PACKAGE 3.4
REACTOR COOLANT SYSTEM (RCS)

MARKUP OF NUREG-1431
IMPROVED STANDARD TECHNICAL SPECIFICATIONS
AND BASES

PRAIRIE ISLAND NUCLEAR GENERATING PLANT
UNITS 1 AND 2

Improved Technical Specifications
Conversion Submittal

Figure 3.4.16-1 (page 1 of 1)
Reactor Coolant DOSE EQUIVALENT I-131 Specific Activity
Limit Versus Percent of RATED THERMAL POWER

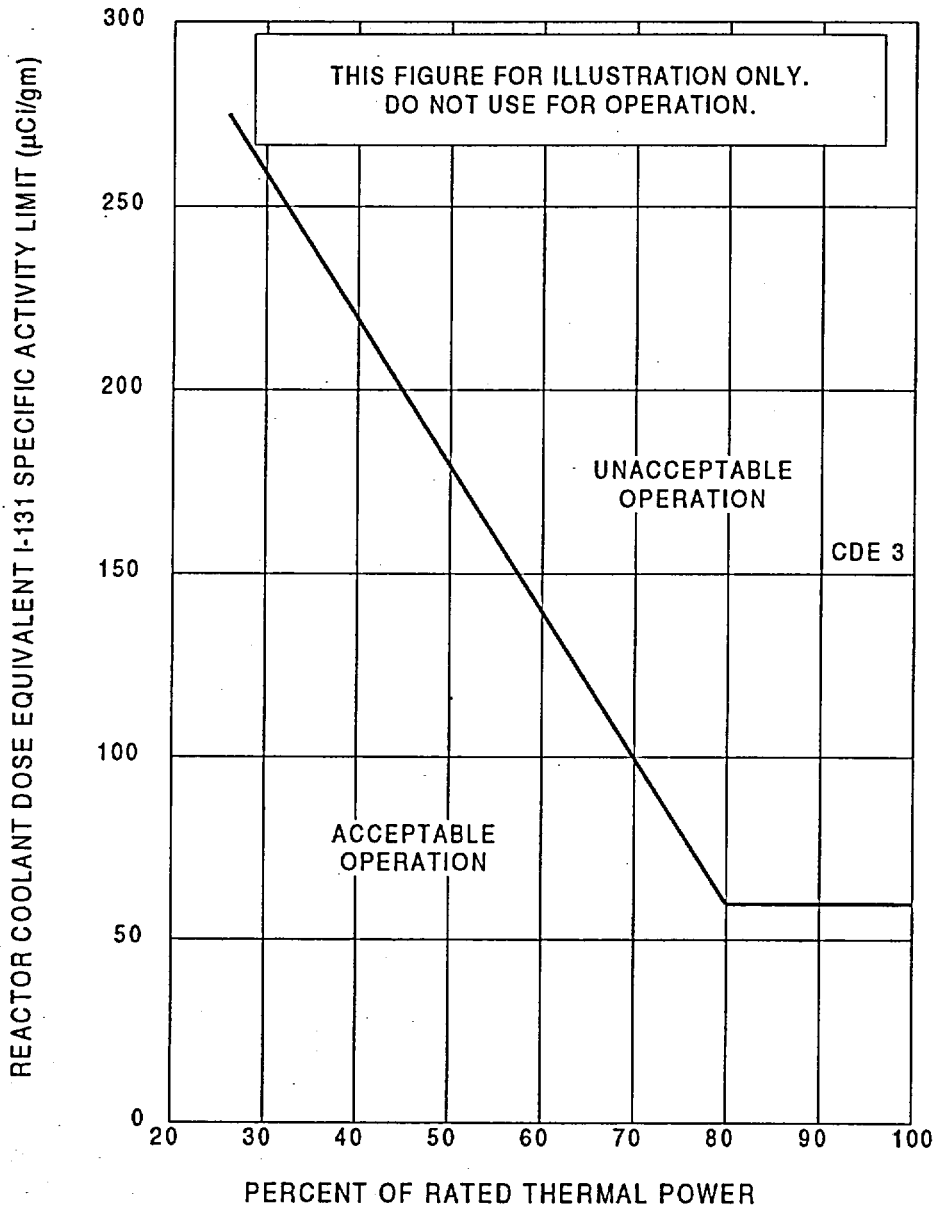
~~Replace with PI specific figure.~~
